MASTER DRAINAGE

LANDS OF RAY A. GRAHAM III

**RE: Grading and Drainage Plan for Lands of Ray Graham (E12-D154) Received  
October 1, 2001 and Letter dated January 28, 2002**

**RE: Master Drainage Plan for Lands of Ray A. Graham III (E12/D15), Engineer's Stamp  
Dated 4/12/99**

EXHIBIT B-1

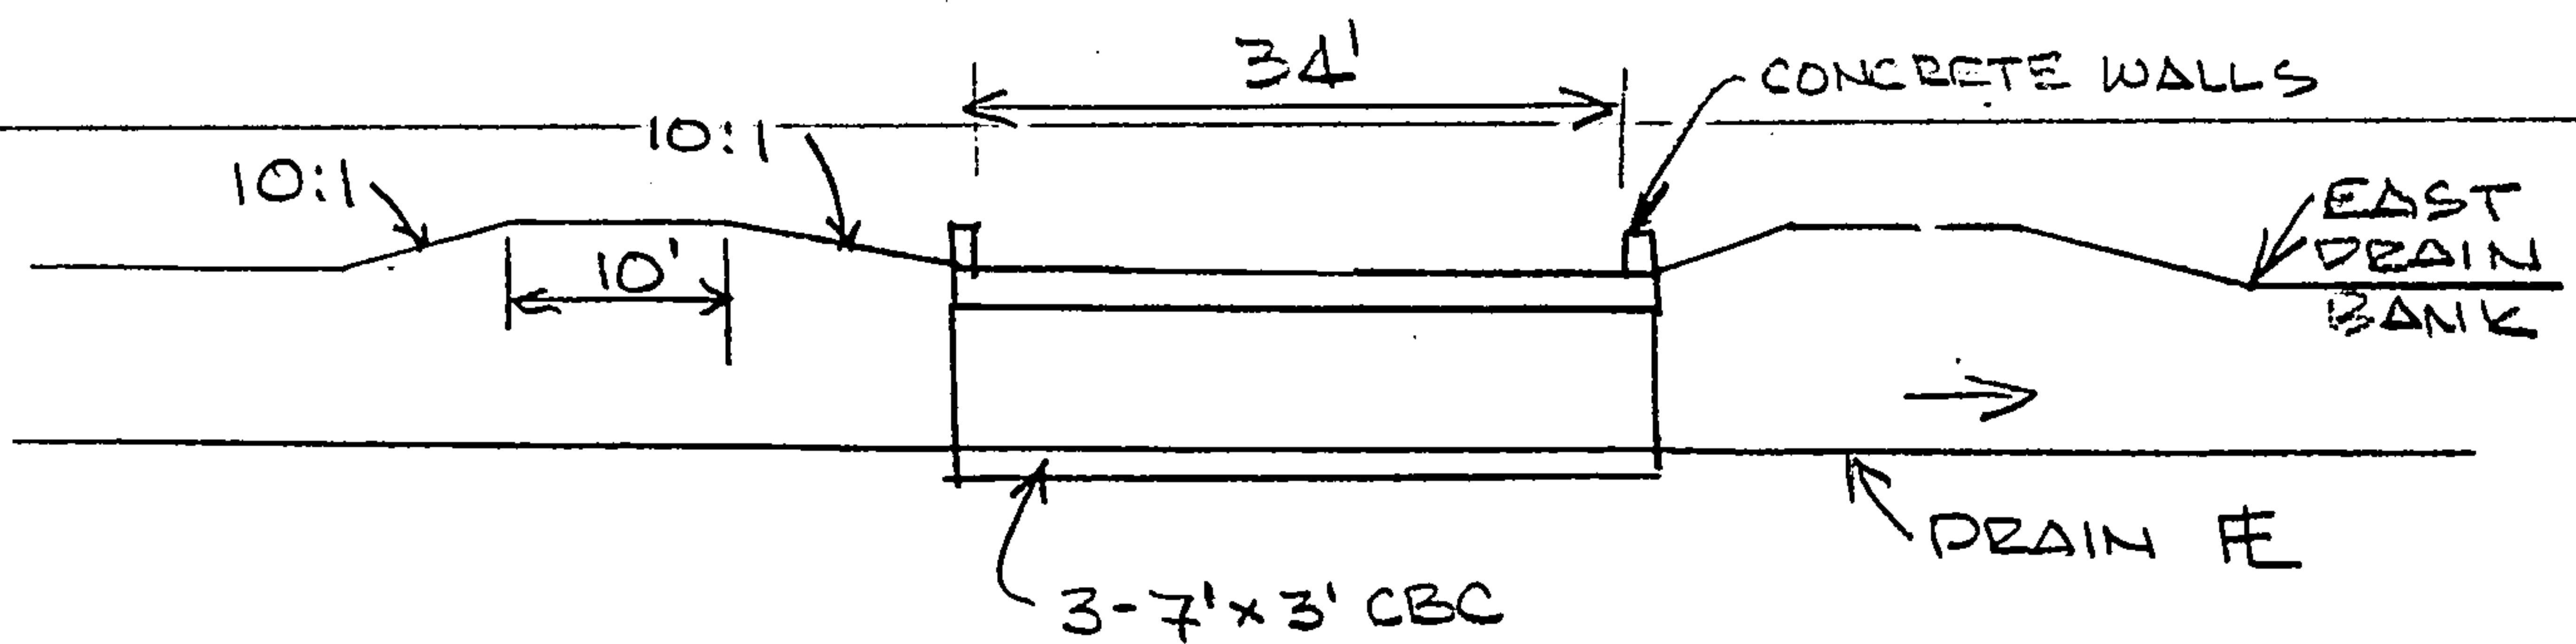
4. MRGCD concurrence will be required prior to development of Basins "C" or "D" for the concept of using the bank of the drain as the spillway.
5. The detail for the Basin "A" outfall is not acceptable. A sufficient design for the proposed street, culverts and roadside channel must be provided. Development of Basin "A" will not be allowed until a design of this outfall meeting the D.P.M. criteria is provided. The Basin "B" outfall must also be designed in detail prior to development of Basin "B."

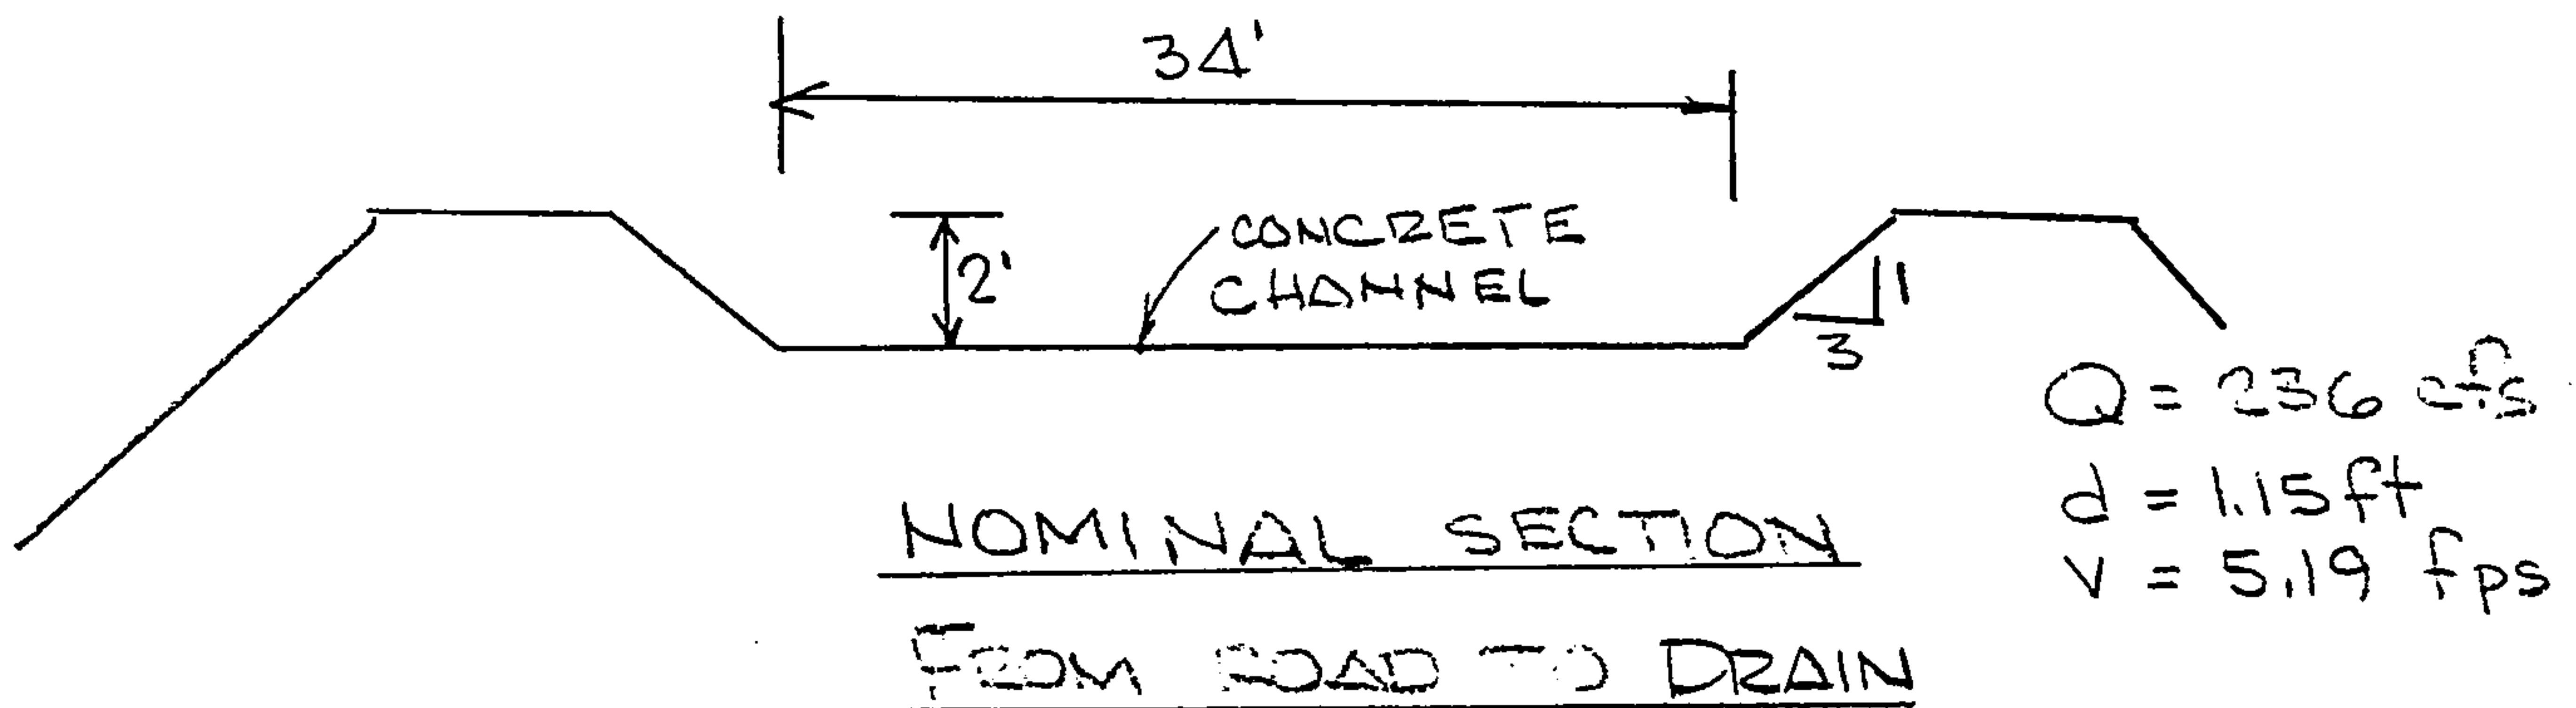
Prior to any development within drainage Basins "A" or "B," complete hydraulic designs for the concrete outfall channels must be provided. It appears that the preliminary grades provided for the "Basin B crossing" are below the existing topography. The plan is not adequate to confirm the existing grades at the "Basin A crossing." The ultimate outfall systems must be designed to meet City standards for future public dedication.

The plan must show how the proposed outfall channels will work hydraulically. Exhibits A and B are not sufficient for this design.
